STAGE 1 ROAD SAFETY AUDIT REPORT FOR 111644: FOOTBALL STADIUM AND TRAINING FACILITIES AT KINGSFORD, ABERDEEN

Report Ref 40817(1) Rev C

Issue Date 20-Jun-17

Appendix A. Location Plan of Problems

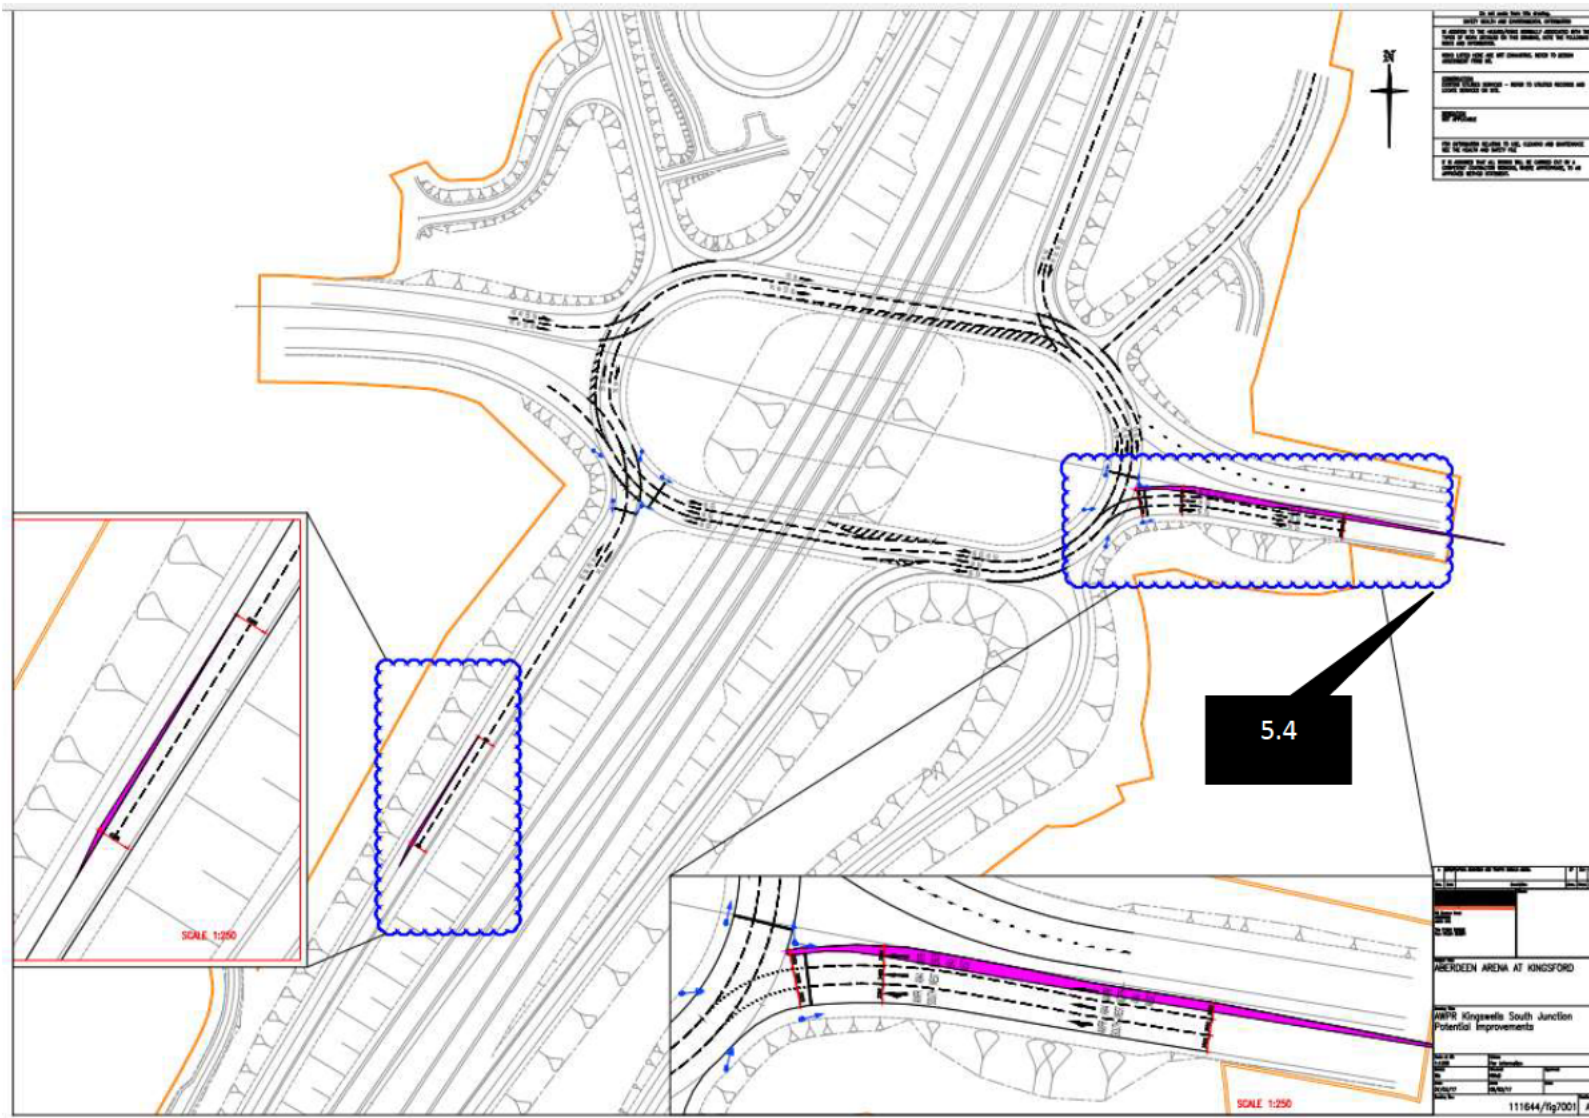
5.1 PROBLEM

Location A944 Main Entrance and approaches.

Summary Risk of serious side impact collision.

The activation of the part-time traffic signals at the stadium and the deployment of temporary traffic management measures on match days will require bollards to be removed from the central reservation, and signs altered in the central reservation and verges on both A944 approaches.

Manually carrying out these tasks requires workers to cross the A944 and work within the central reservation. This exposes them to the risks of being struck by a vehicle.

The continual installation and removal of temporary bollards will no doubt lead to excessive wear of the bollards and likely loss or misplacement of them. Through time it should be anticipated that some bollards will get broken or lost and the gap in the central reservation will not be securely closed during non-match days. The recommended route for westbound traffic to enter the site on non-match days is to drive past the site, through the signalised A944/B9119 junction and carry out a U-turn at the Arnhall roundabout, then back through the signalised junction before turning left into the site. An opened central reservation gap at the main entrance will tempt some drivers to avoid the recommended route and turn right through the gap and across the eastbound traffic flow. This will increase the possibility of a serious side impact collision with eastbound traffic who will not be expecting traffic to turn across their path.

5.2 PROBLEM

Location A944 and west entrance.

Summary Risk of pedestrian injury collisions.

Arnhall Business Park can provide car parking spaces during match days as well as bus stops for public bus services. Drawing 111644/sk8013 also shows a length of Venture Drive being used for as a Taxi drop-off and pick-up area. This has the potential to generate over 1800 pedestrians walking eastwards from the business park to the stadium, and returning after the game. Pedestrians will want to take the most direct path, which is likely to be from Venture Road and along the A944 dual carriageway to a crossing point near the stadium. Guardrail will contain the pedestrians to the footway. Drawing No 111644/sk8013 shows a demountable length of pedestrian guardrail opposite the entrance to the stadium. Further east there is a controlled Toucan crossing facility within the signalised A944 / B9119 junction.

It is proposed that when pedestrian flows are highest during match days the demountable barrier is removed to allow pedestrians to cross the A944 towards the stadium. This will create an uncontrolled crossing of a 40mph dual carriageway.

The uncontrolled crossing of the A944 dual carriageway by large numbers of pedestrians will present a risk of pedestrian and vehicle collisions. Pedestrians stepping out into the path of approaching vehicle will lead to sudden braking and shunt type collisions which may result in pedestrian injuries.

5.3 PROBLEM

Location A944 near east access.

Summary Risk of vehicle strike with redundant roadside furniture.

Near the east access there are existing signs that warn of cattle crossing. As the field to the north of these signs is to be developed there may no longer be a need for cattle to cross the A944. Redundant signs are an unnecessary distraction to drivers as well as being a roadside hazard that any errant vehicle could hit.

5.4 PROBLEM

Location A944 eastbound approach to AWPR Kingswell South junction.

Summary Risk of side swipe collisions due to late lane changing.

During periods of traffic queuing the road markings will be obscured by queuing vehicles and drivers will have inadequate advance notification of the lane destinations. This will result in late or sudden lane changing manoeuvres which can contribute to low speed side impact or shunt type collisions.

1. The bollards or barriers that close the central reservation gap are of a type that can be activated by a remote electronic switch, thereby removing the risk associated with having workers and vehicles in the central reservation.
2. That the advance signs that warn of when the traffic signals are operating and of the temporary lane destination are of an electronic type that can be operated remotely.

1. The preferred pedestrian route from Arnhall Business Park to the stadium is from Venture Road, along the south footway of the A944 to the controlled Toucan crossing at the signalised junction of the A944 and B9119.
2. Only when pedestrian flows are likely to exceed the capacity of the Toucan crossing should the demountable barriers be removed and the uncontrolled crossing activated. The operation of the uncontrolled crossing will require the assistance of the match day Police who will have powers to stop traffic. A

operational procedures plan must to be put in place which includes a risk assessment and training of stewards.

It is recommended that all redundant signs are removed.

It is recommended that the advance direction signs are altered to reflect the 3 lane approach and their destinations.
